Revision "F"

F Relocate signal heads for East leg modification. April 22, 2004
S.H.A. No.: BW996M82
JES

MARYLAND DOT - STATE HIGHWAY ADMINISTRATION
Office of Traffic & Safety
TRAFFIC ENGINEERING DESIGN DIVISION
(Traffic Signal Plan)

MD 210 (Indian Head Hwy.) at Old Fort Road - South

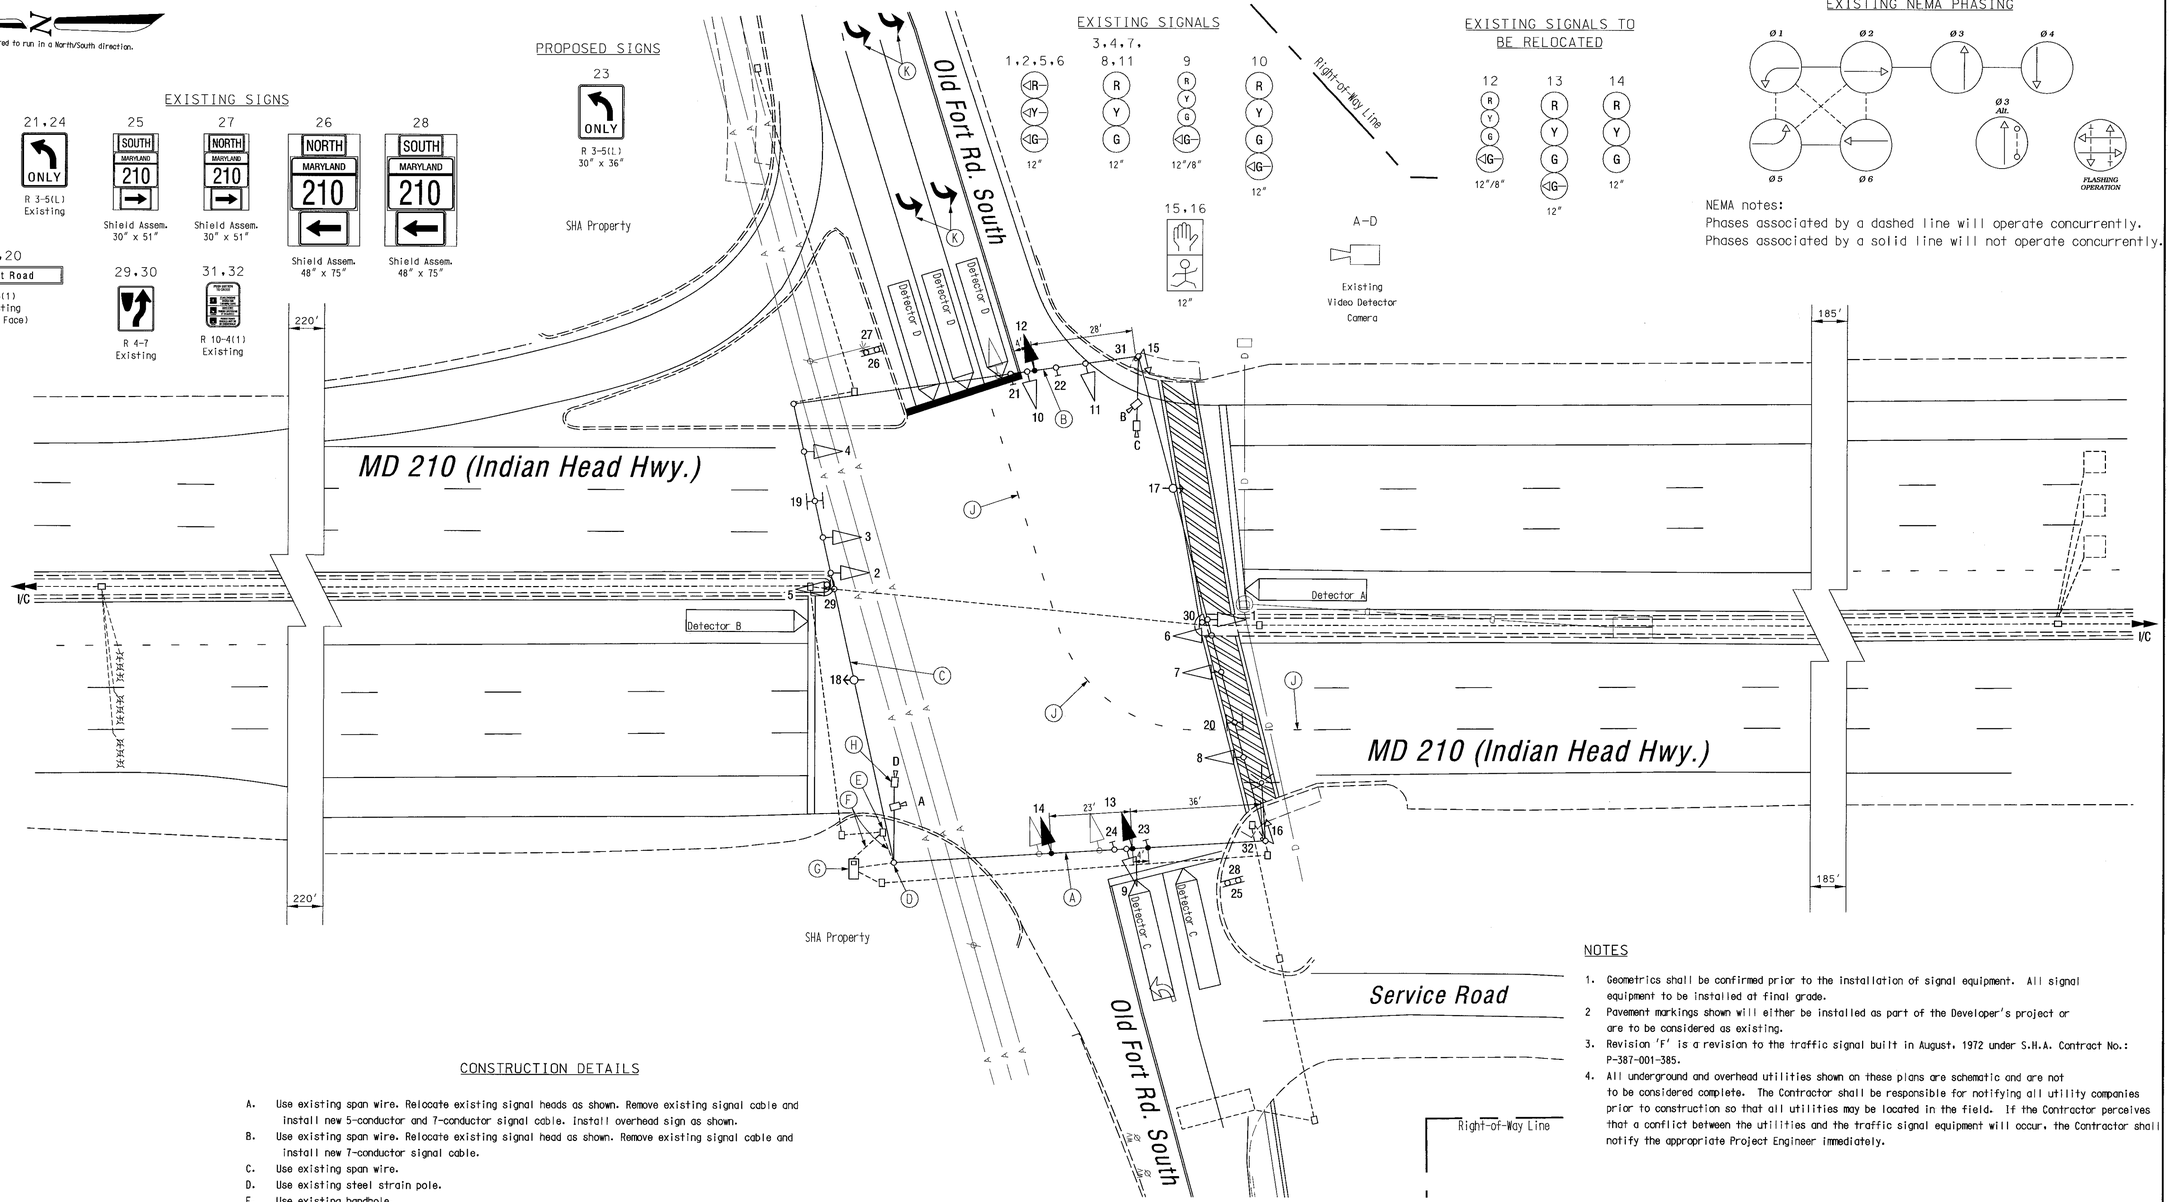
A. Use existing span wire. Relocate existing signal heads as shown. Remove existing signal cable and install new 5-conductor and 7-conductor signal cable. Install overhead sign as shown.
B. Use existing span wire. Relocate existing signal head as shown. Remove existing signal cable and install new 7-conductor signal cable.
C. Use existing span wire.
D. Use existing steel strain pole.
E. Use existing handhole.
F. Use existing conduit.
G. Use existing cabinet.
H. Realign existing video detector camera (letter D).
J. Install 5 in. wide dotted pavement marking 3ft. segment - 9ft. gap) - white for lane line.
K. Pavement marking symbols installed by others.
